Laney

Service Diagrams

VH100R OVERDRIVE & OUTPUT DIAGRAM
 PART No

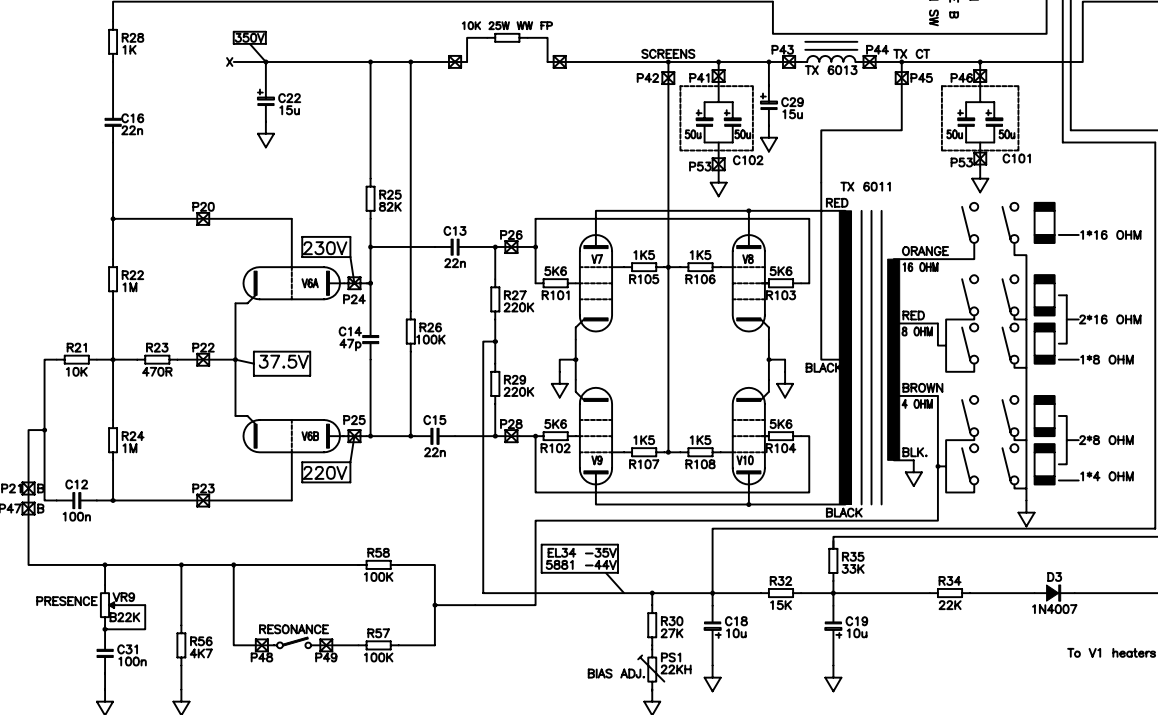
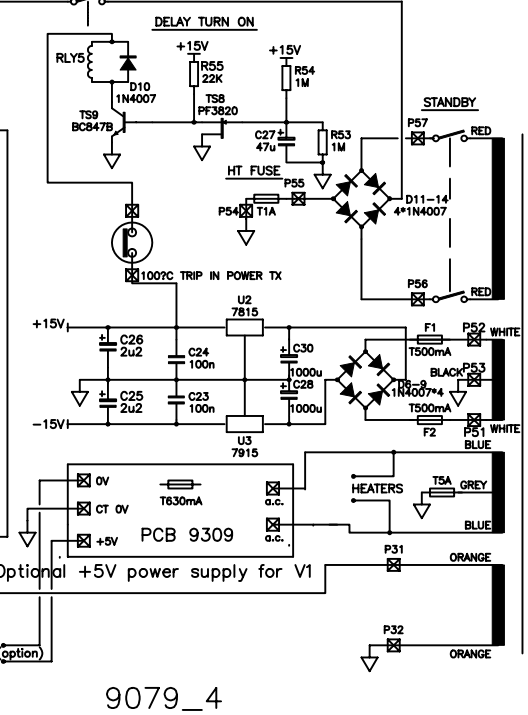
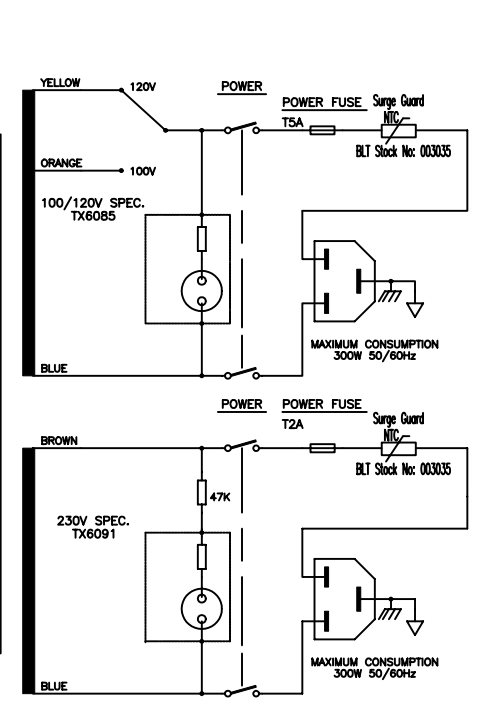
ISSUE	DESCRIPTION	APPD.	DATE
4	CHANGE R46 & R41 FROM 2 OFF 22K TO A SINGLE 10K 25W FIRE PROOF CHANGE R14 & 23 FROM 10K 1W TO 10K 4W FIRE PROOF ADD 1000°C TRIP TO POWER TX ADD F1 & 2 AS T500mA ADD 2 CHASSIS MOUNT FUSE CARRIERS WITH TSA TO HEATER WINDINGS CHANGE POWER TX FROM 6086 TO 6091 230V Option added for regulated +5V supply for V1, dependent on valve type	S.L.	14/9/95
5		R.J.F	5/10/98
6	SG64 Surge Guard added to primary of mains transformer.	RT	21/11/01

DRAWN	DEH
DATE	25/07/95
TITLE	4 CHANNEL VALVE AMP CLEAN CHANNEL
DRW. NO.	9078-4

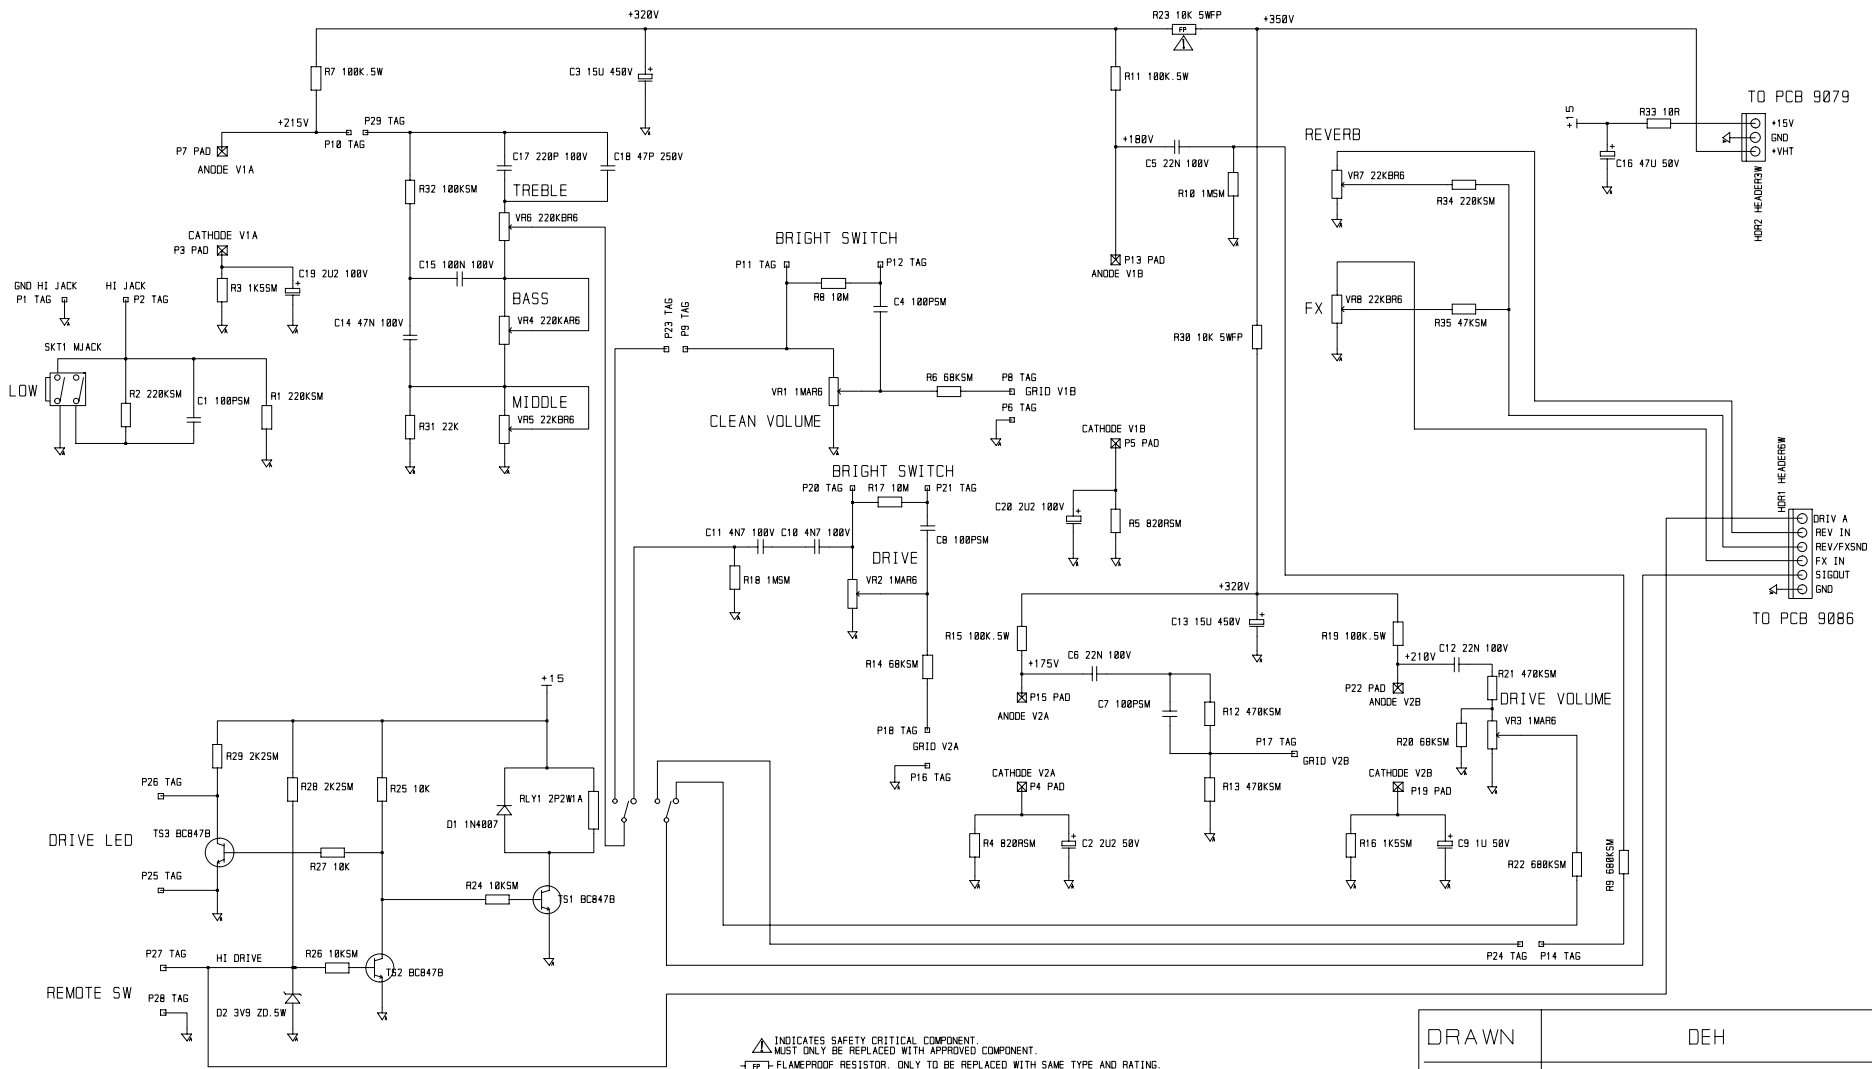
ISSUE	C19/20 2U2 ADDED 26/07/95 R23/30 18K 1W CF TO 5W WW FP 26/07/95
TYPE

DRAWN	DEH
DATE	25/07/95
TITLE	4 CHANNEL VALVE AMP FX MODULE
DRW. NO.	9086_4

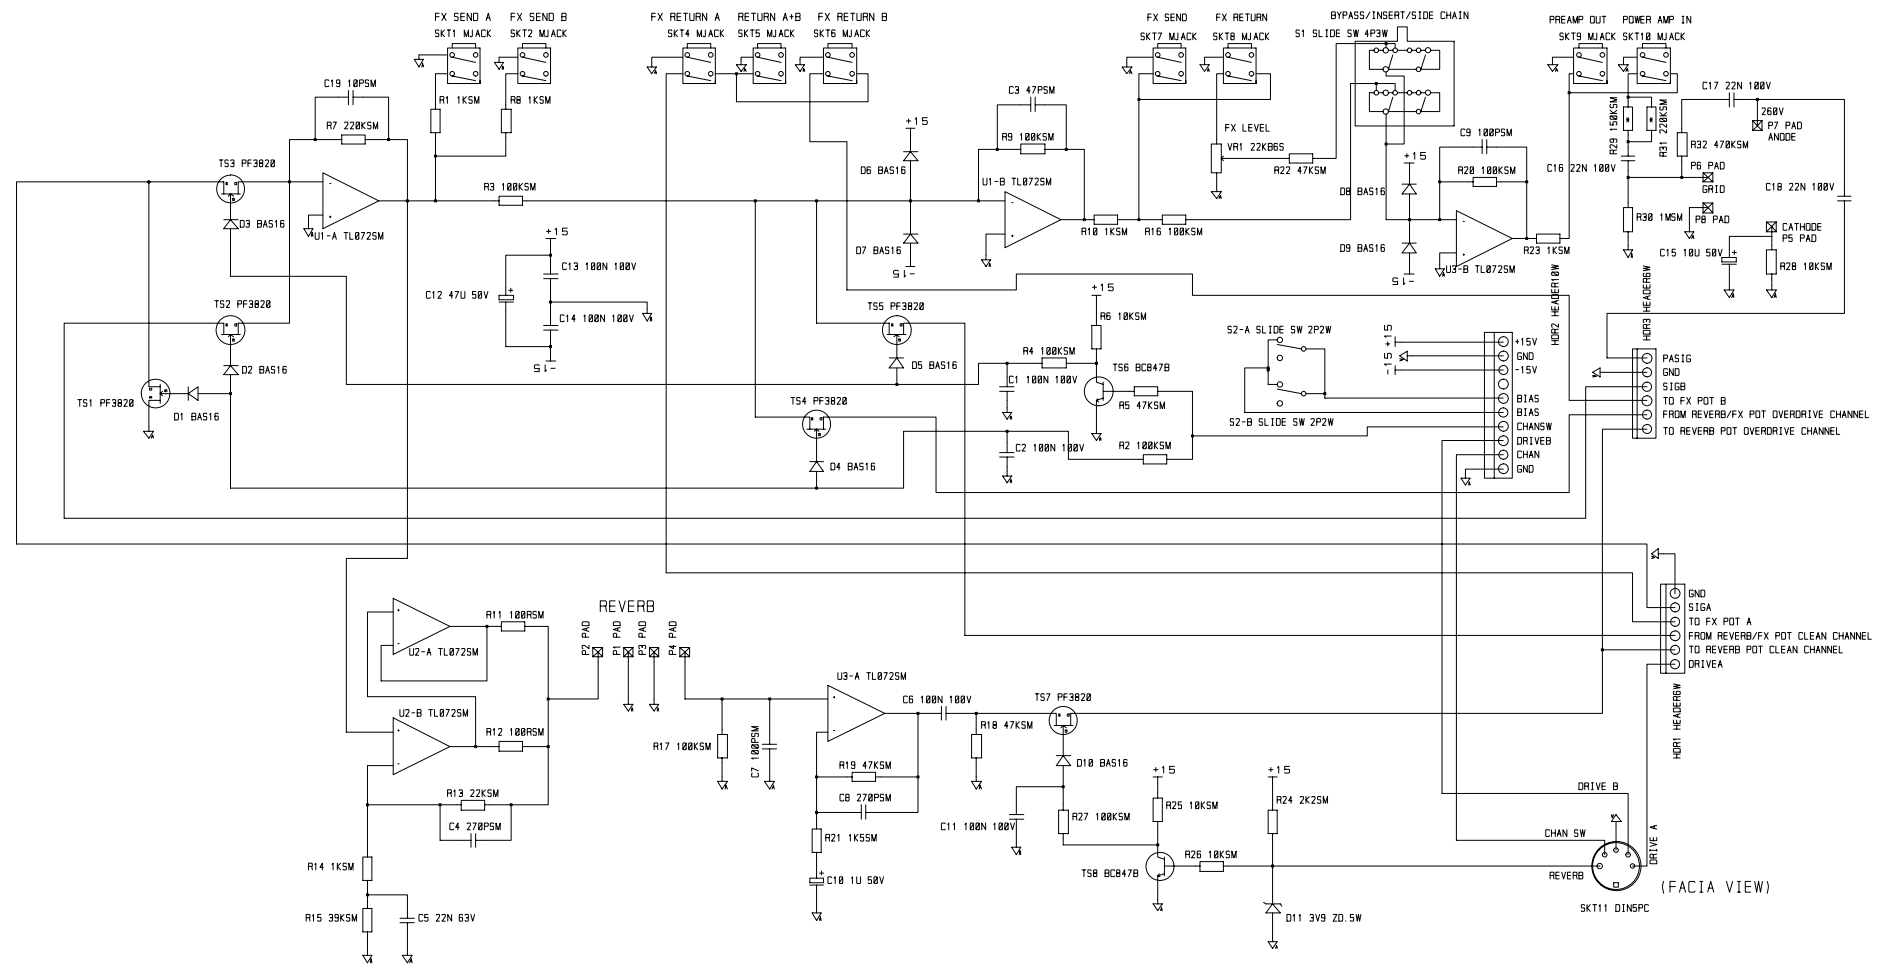
ISSUE	C19 ADDED 19/04/95 R13 47K TO 22K 19/04/95
-------	---
